NUMBER: 83-26

- A. Replacement Drive Shafts - MCM 120R/140R/898R/228R/260R
With Extension Shaft Kit
- B. Engine Alignment Tool (91-57797A3) Modification

Figure 2. Alignment Tool Modification

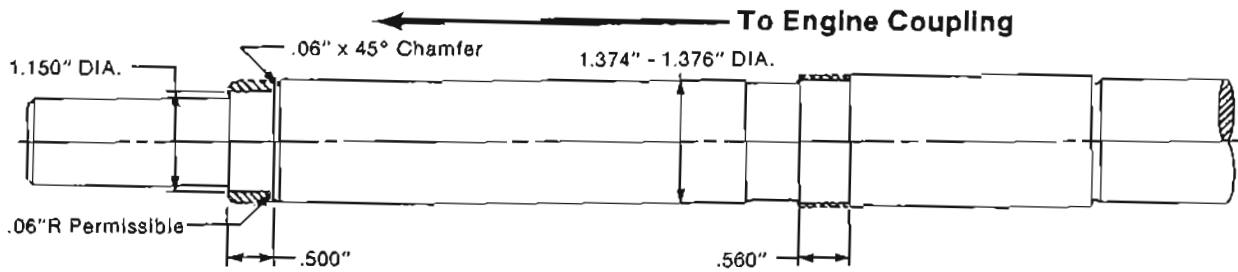
To ensure more engine coupler engagement during the alignment of MCM 470R and 488R model engines, please modify the alignment tool as shown in Figure 2. This modification will improve engine coupler engagement on the other model engines also.

IMPORTANT: DO NOT remove more than .560" from gimbal bearing area of alignment tool. This .560" dimension ensures that the gimbal bearing will straddle the existing "under cut" in alignment tool.
